HISTORIC AND DESIGN REVIEW COMMISSION

October 20, 2021

HDRC CASE NO: 2021-504
ADDRESS: 125 MAGNOLIA DR
LEGAL DESCRIPTION: NCB 6530 BLK 2 LOT 7
ZONING: R-4,H
CITY COUNCIL DIST.: 1
DISTRICT: River Road Historic District
APPLICANT: Sheryle Leal/Precision Contracting
OWNER: Hannah Olguin
TYPE OF WORK: Exterior modifications, construction of a front porch
APPLICATION RECEIVED: September 24, 2021
60-DAY REVIEW: Not applicable due to City Council Emergency Orders
CASE MANAGER: Stephanie Phillips
REQUEST:

A-2.0

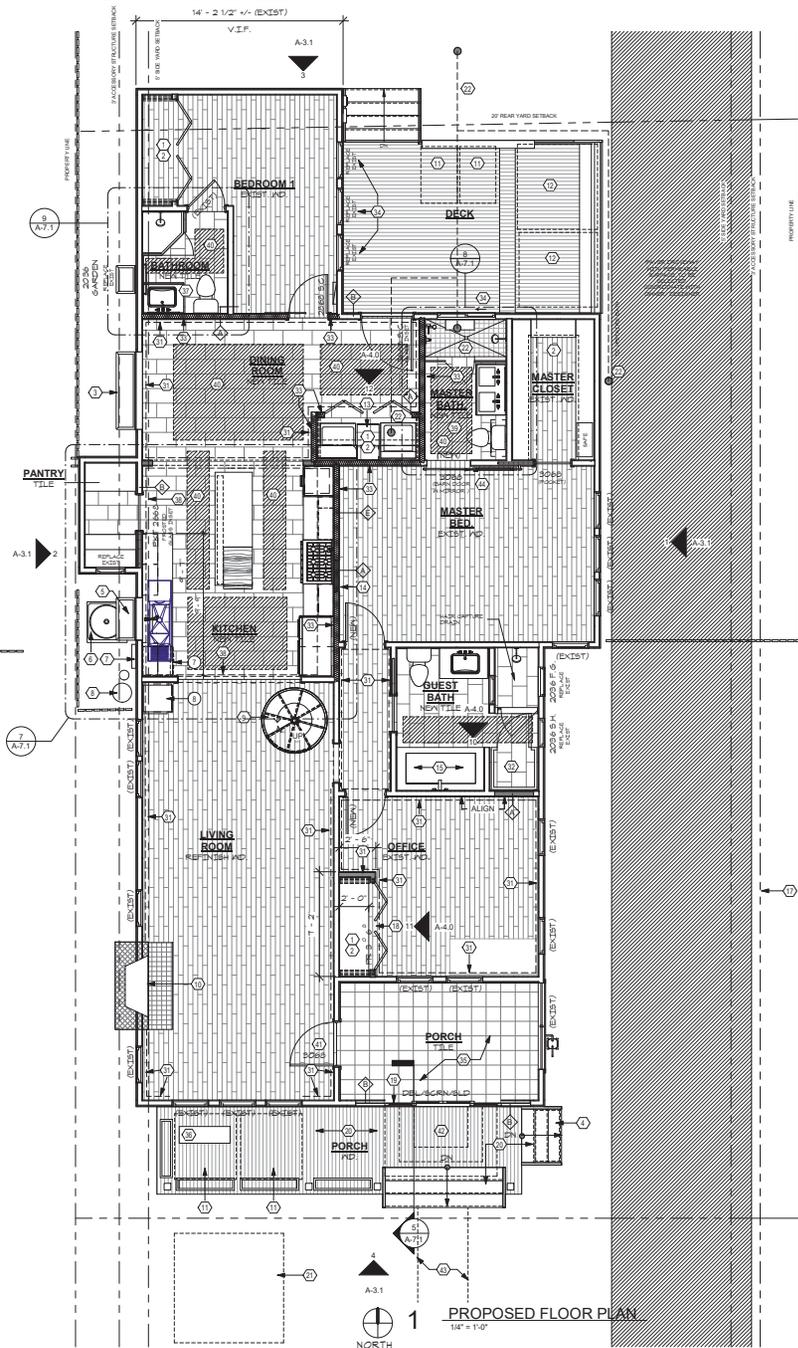
- c. FRONT ENTRYWAY CONFIGURATION MODIFICATIONS – The applicant has proposed to modify the existing front door and entryway configuration. The current configuration features a one over six screen door centered between two full-height window screens with a mullion and muntin pattern that echoes the proportion of the existing historic windows on the house. The door and window screens fill the opening of the original front porch as evidenced on the 1911-1951 Sanborn Map. Based on the submitted elevations, the applicant has proposed to replace this configuration with new wood screened slider doors flanked by full height screen doors and infill the remaining wall with siding. Per the Historic Design Guidelines, alterations to porches should result in a space that functions, and is visually interpreted as, a porch. Use the exterior muntin pattern, profile, and size appropriate for the historic building when replacement windows or screens are necessary. Staff finds that the existing porch configuration visually reads as an enclosed front porch featuring screen and door designs that are specific to the proportions found on the historic home, which helps clearly tell the story of the evolution of the home over time. Staff finds that the existing screened porch configuration should be retained. Replacing the existing door and screens with a new door and screens clad with a similar mullion and muntin pattern is eligible for administrative approval.

- d. NEW FRONT PORCH – The applicant has proposed to install a front porch with a low-sloping shed roof with rafter tails. The porch will measure approximately 25 feet in length, just shy of the width of the front façade, and will extend 6 feet in depth towards the street. Per the setback diagram submitted by the applicant of the property, a 13' setback will remain from the sidewalk. According to Guideline 7.A.i, new porches should not be added where historically present and new front porch elements should be simple as to not distract from the historic character of the building. Details should not convey a false sense of historic appearance. Per Sanborn Maps, there is evidence that a recessed porch existed historically on this property and was enclosed over time as noted in finding e. The current proposal requests to add a second porch where one did not historically exist. Additionally, based on the information provided, the front porch may have a setback that is closer to the street than existing porches on surrounding properties. A street setback diagram has not been provided by the applicant that illustrates the new porch setback in relationship with neighboring properties. Staff does not find the proposal consistent with the Guidelines.

Item 1, Staff does not recommend approval of the front entryway modifications as proposed based on finding c. Staff finds that this existing configuration should be retained. Replacing the existing door and screens with a new door and screens clad with a similar mullion and muntin pattern is eligible for administrative approval.

Item 2, Staff does not recommend approval of the construction of a new front porch based on finding d.
